PROPOSED CONTRACT CHANGE

Contract No. 1252 Tunnels Date 03/01/2013
 PCC No. 1252-10 (Revision 01)
 PCC Title Relocation of TBM Retrieval Shaft

Description of PCC:

EXHIBIT A
12/28/2012

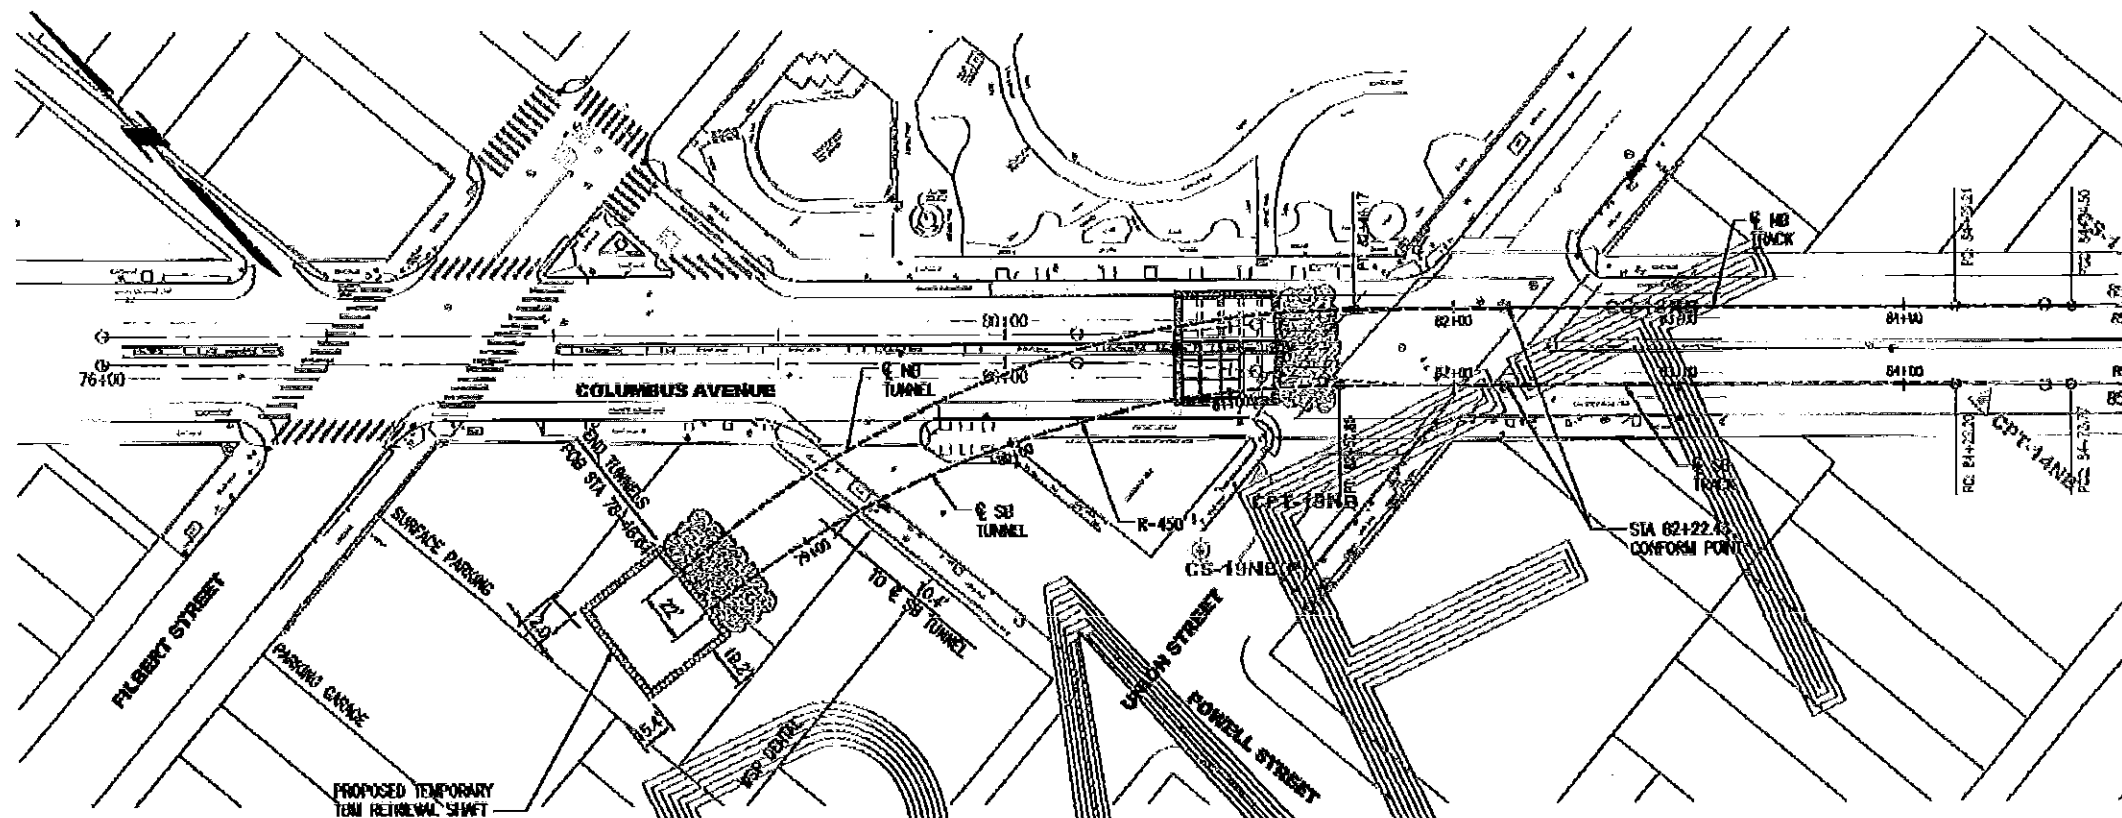
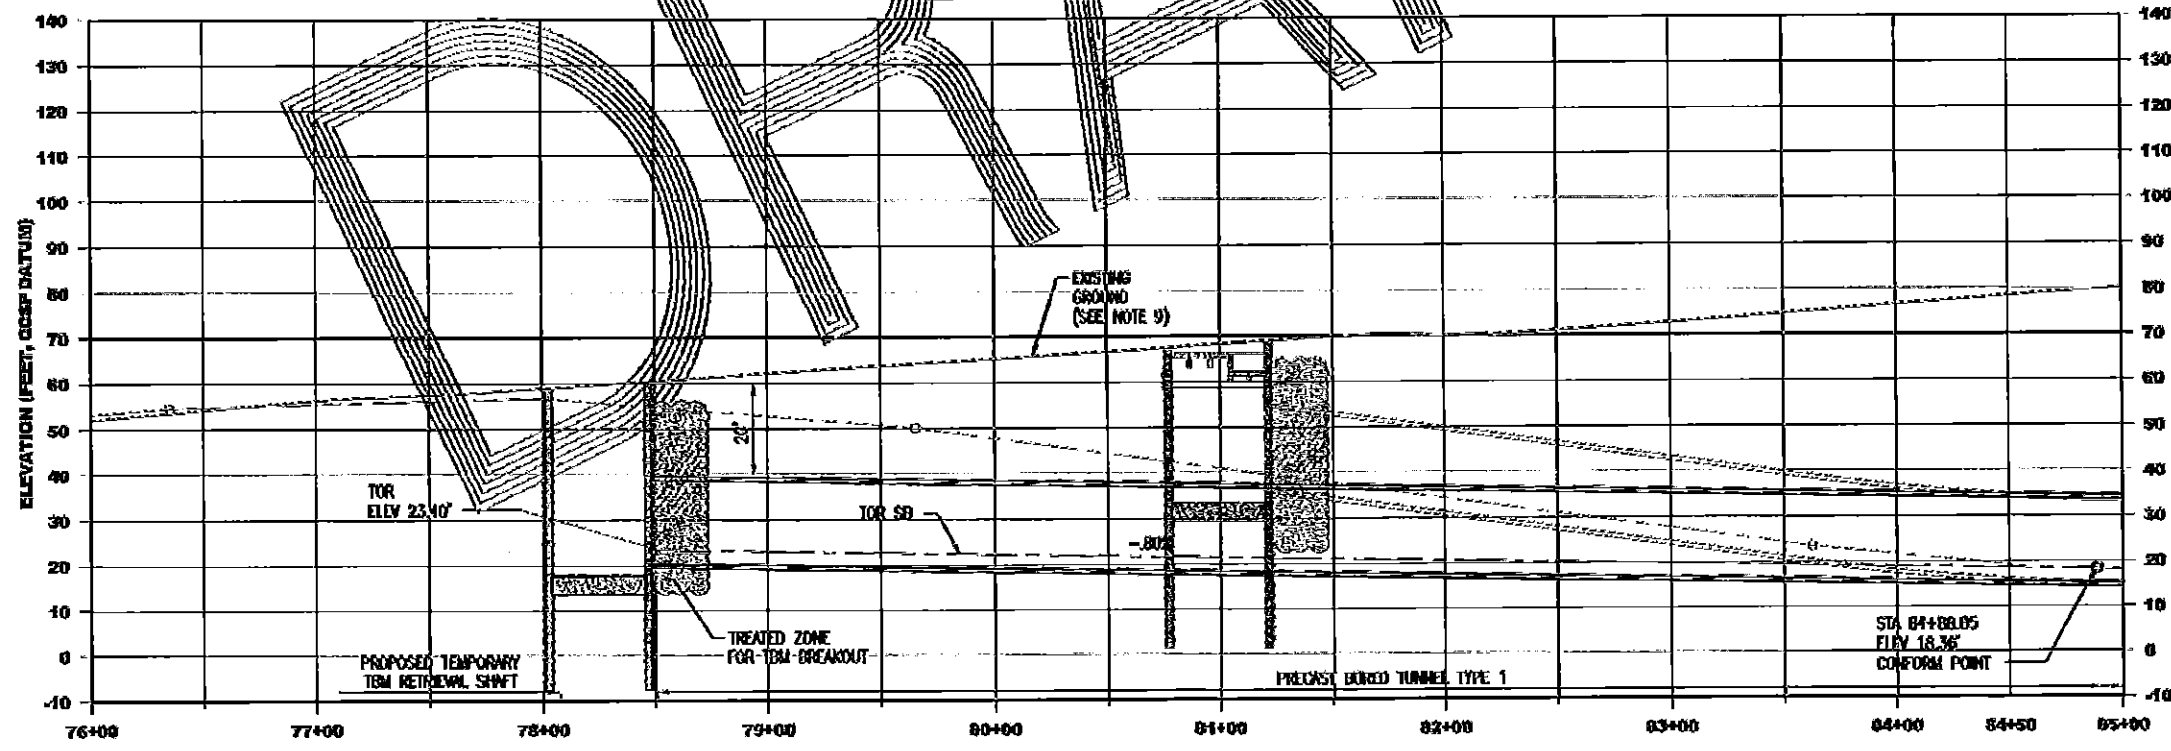
1. Deletion of the TBM Retrieval Shaft on Columbus Ave. and deletion of associated utility relocation and surface restoration.
2. Design and Construct an extension of twin bore tunneling from the currently shown end at Sta. 81+23 approximately 274 feet to the relocated Retrieval Shaft. Length of extension subject to refinement of Retrieval Shaft location.

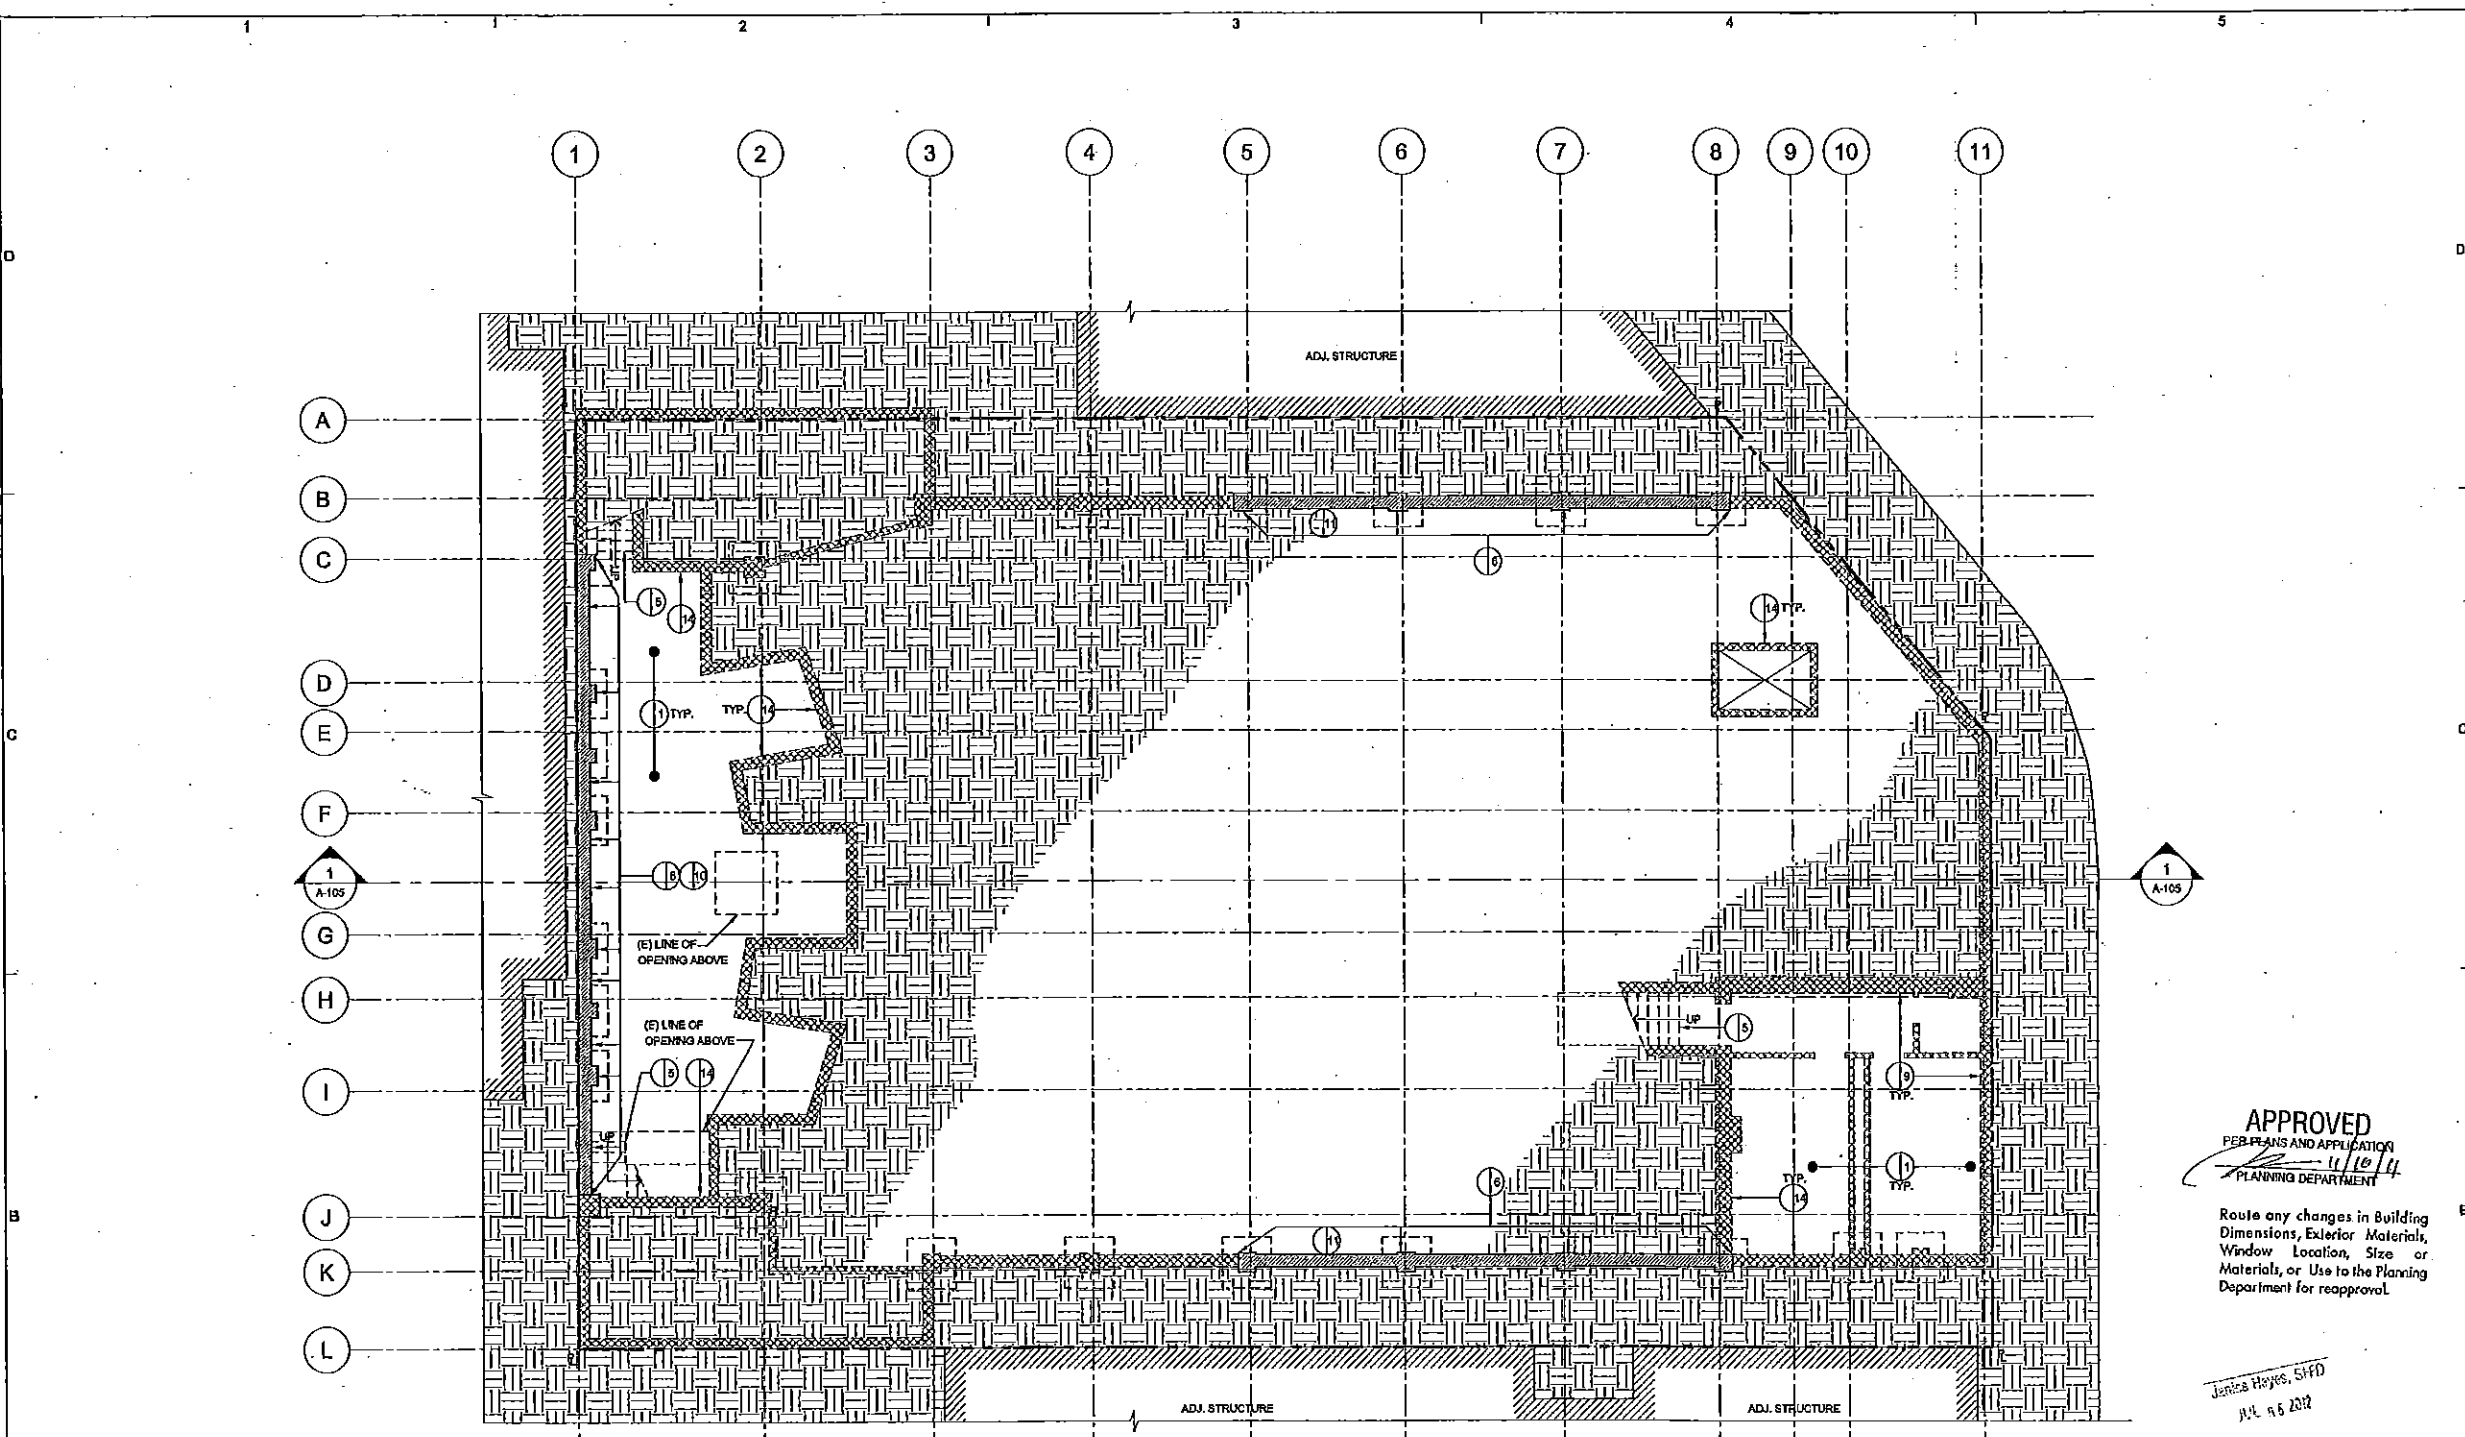
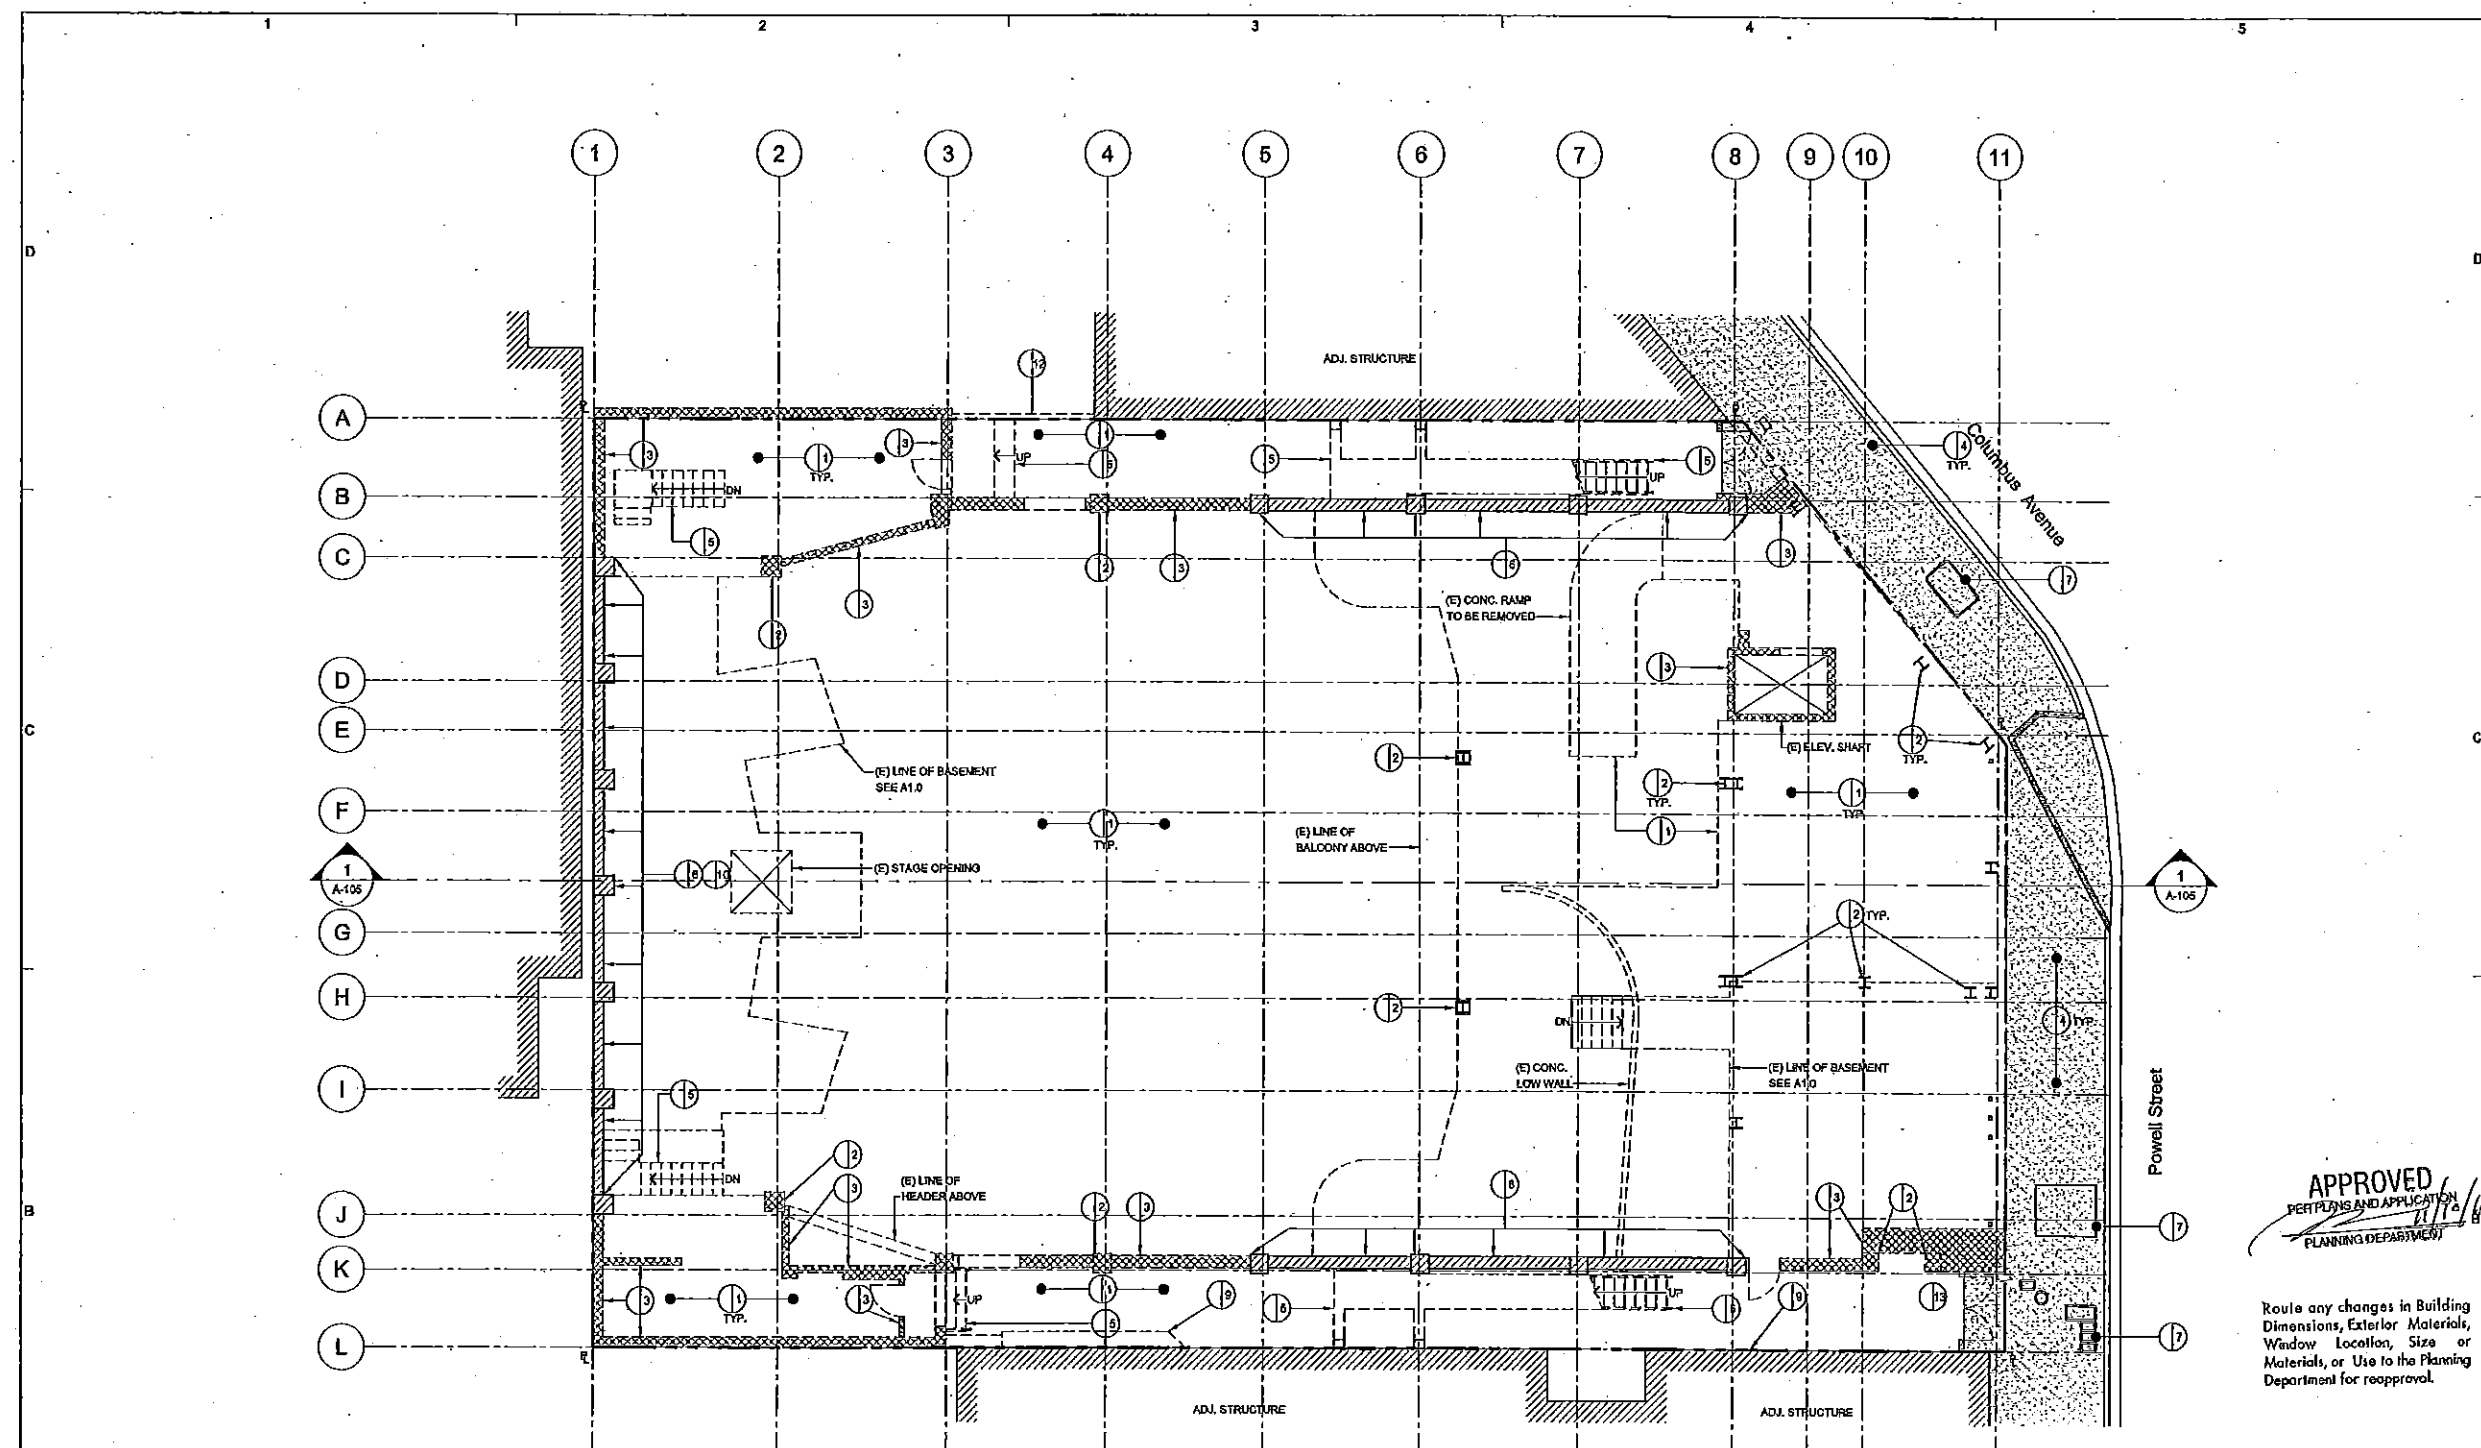
3. Design a demolition plan and demolish existing building at 1731-1741 Powell Street. Demolition to include entire building; roof trusses and perimeter walls are not to be retained as shown in the attached representative Demolition Drawings. Note: Below grade structures required for support of adjacent structures to be left in place.
